19 September 2016

**National Trust of Australia (Victoria) submission-in-chief
Melbourne Metro Rail Project EES hearing**

Figure 4. View south-west from Linlithgow Avenue to Walker Fountain. The majority of trees visible will be lost if soil grouting proceeds.

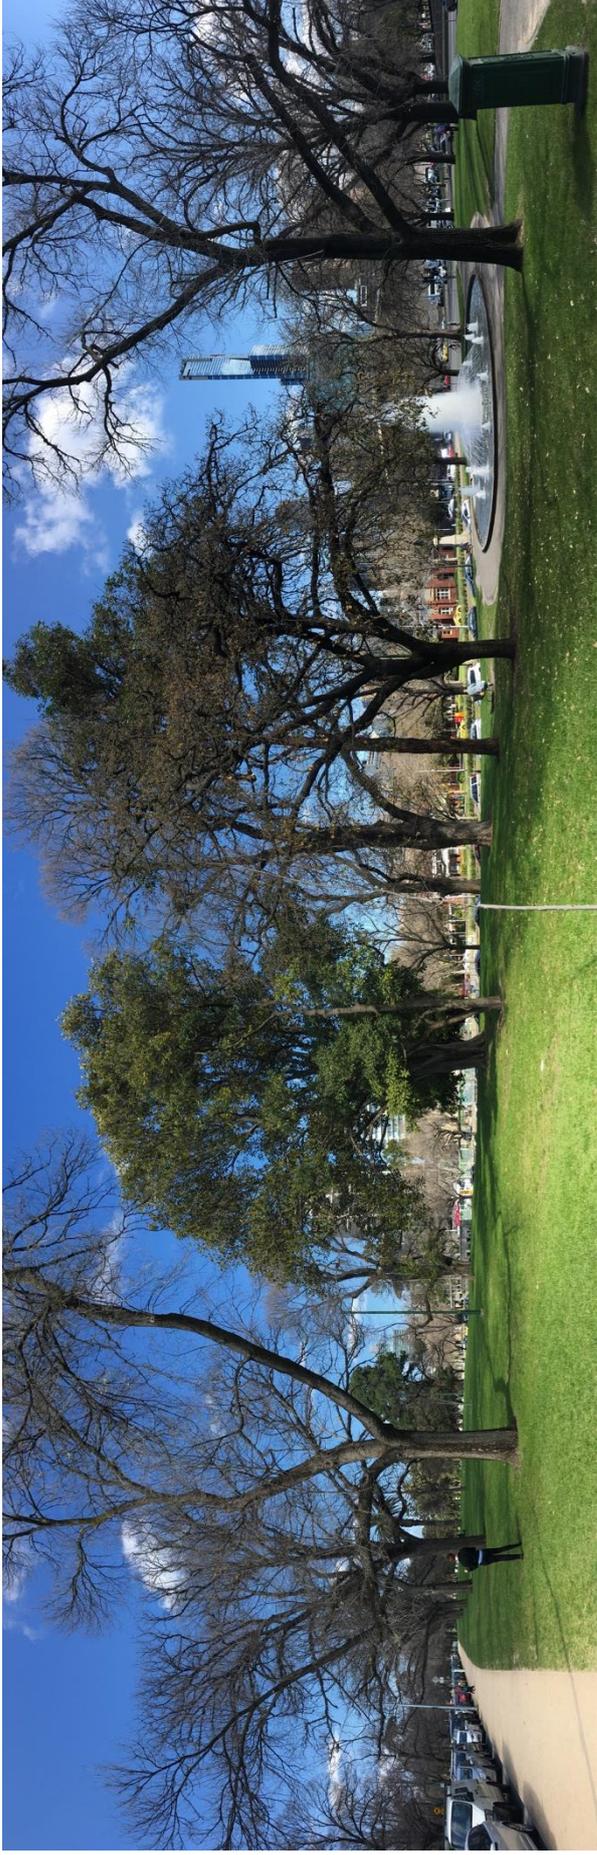
Tom's Block and the Shrine Reserve are places that are sacrosanct to Victorians. The project should be undertaken in a way that provides certainty that the landscape of Tom's Block is able to be reinstated and re-established. It is the submission of the National Trust that, based on the evidence provided, the only way to ensure certainty at the time of this EES assessment is to mandate that the tunnel alignment proceed under CityLink.

Figure 10. Scope of tree loss in Tom's Block based on Technical Note 47. 70 trees will have major Tree Protection Zone (TPZ) encroachment (>10%, marked red), 11 trees will have minor TPZ encroachment (<10%, marked yellow) (Image: City of Melbourne).

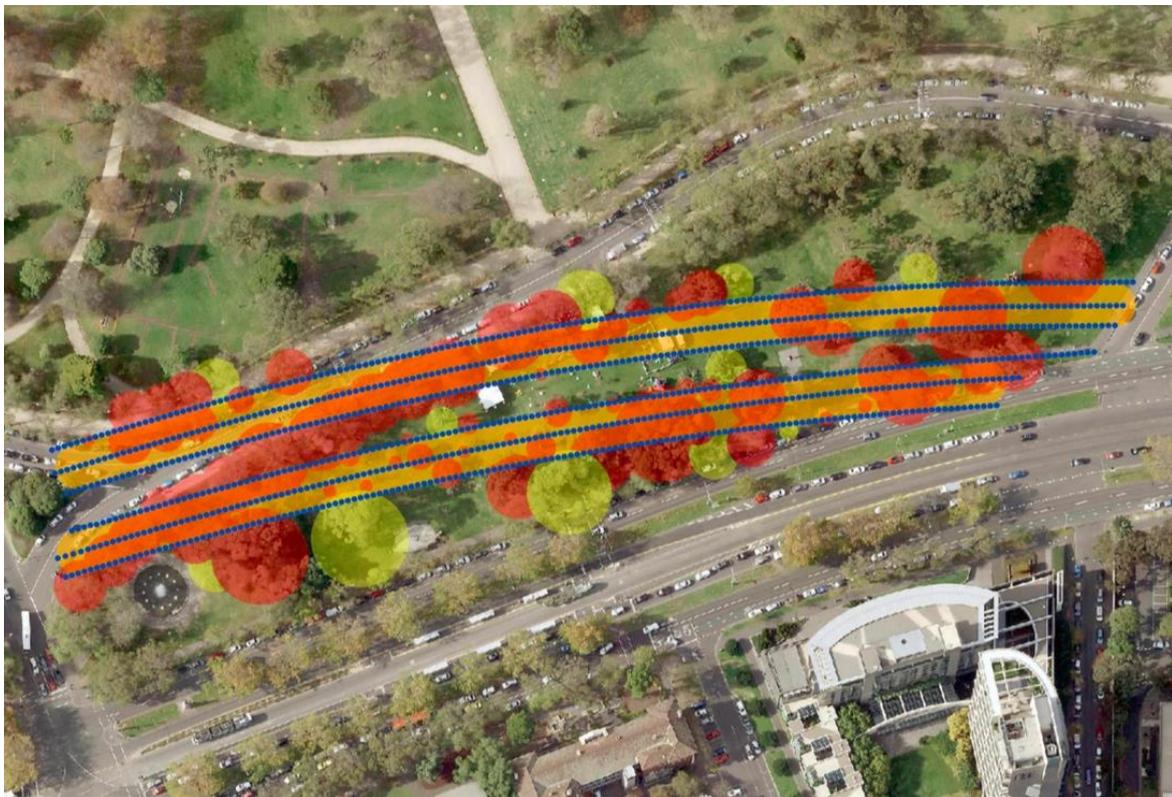
On the basis of Technical Note 47, Mr Shears' evidence was that he did not expect the trees to survive the proposed works and Mr Patrick's evidence was that more analysis of species is required to understand the impact of grouting on trees in the Domain. Mr Shears gave evidence that pumping cement into the soil would not be a precise procedure, with the liquid spreading under ground and expected to have a broader impact than that illustrated in Technical Note 47 – this is extremely concerning given the consequences for the treed landscape.

Mr Patrick characterised the canopy cover as dense within the Domain, and accepted that if the trees fail due to the concrete injection, there will be two linear scars across Tom's Block. Reading the figure provided by Mr Shears (Figure 10), there are only one or two existing trees currently in the centre alignment between the two lines of grouting. On this basis, this work will leave a scar more than 35 metres wide along the length of the 340 metre grouting area. By scaling off Figure 10, the scar will be more than 50 metres wide for approximately half the length of the grouting, increasing up to 75 metres wide in some locations as large trees adjacent to the works are subjected to major encroachment into their tree protection zones.

A 35- to 75- metre gap in the dense canopy cover of the Domain that extends over 340 metres is an unacceptable impact on the landscape and, in the National Trust's submission, is an impact so catastrophic that it cannot be adequately mitigated to ensure the broad character of the Domain is reestablished.

We have formed this view on the basis that the top metre of soil will be disturbed every two metres by the injection of grouting, and furthermore, there is a very high risk of soil compaction at the surface and damage to adjacent trees. Peer-reviewed research discussing soil depth, in the context of its relationship to the risk of windthrow in Appendix 1.

The National Trust strongly advocates for the lower alignment under the CityLink tunnels, as the upper alignment poses an unacceptable risk to the state significant Domain Parklands.

Figure 13. Finlay Avenue of Elms, Camperdown. Replacement trees have been boxed red to show relative growth rates. The smallest tree was replaced twice.

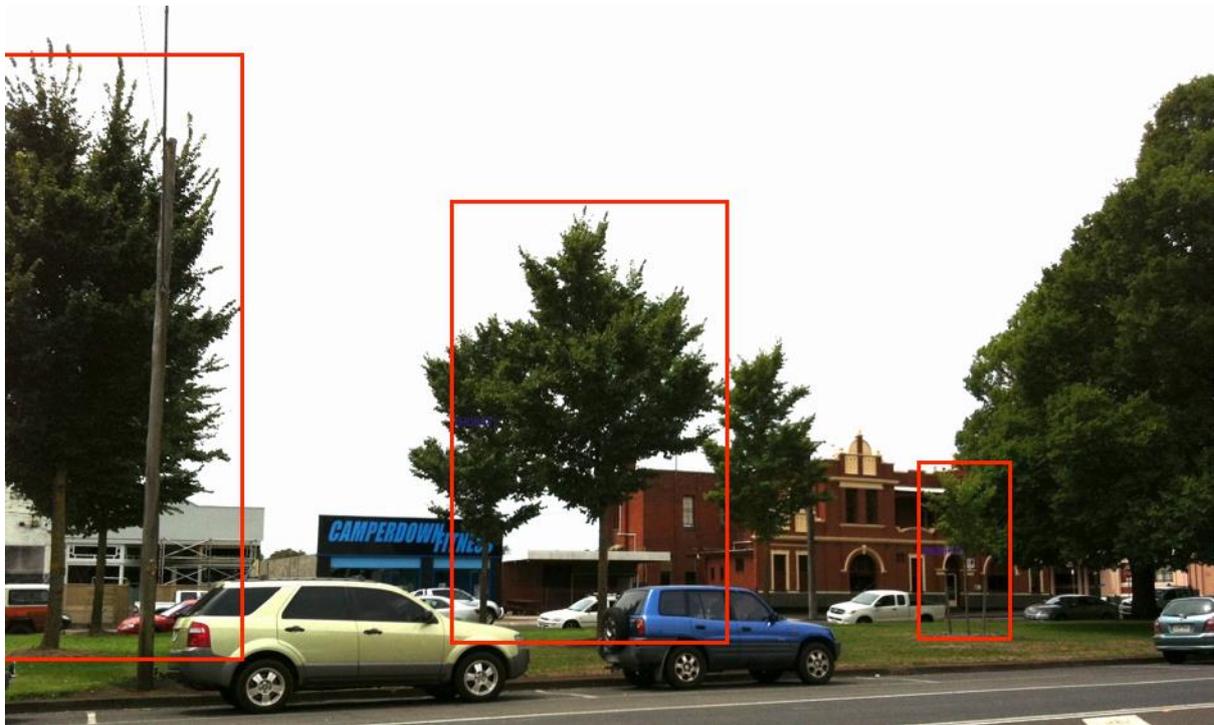
For the Committee's interest, Camperdown provides an example of an elm avenue on the Victorian Heritage Register (H0647) which is currently undergoing block replacement of trees. It is clearly visible that the replacement trees closest to the heritage trees are showing less vigour – they have only grown to half the height of those that have not competed for resources with established trees.

Figure 14. Finlay Avenue of Elms in Camperdown. Block replacement of only 3-6 trees per block maintains the amenity and heritage significance of the Avenue which still achieving a gradual succession plan.
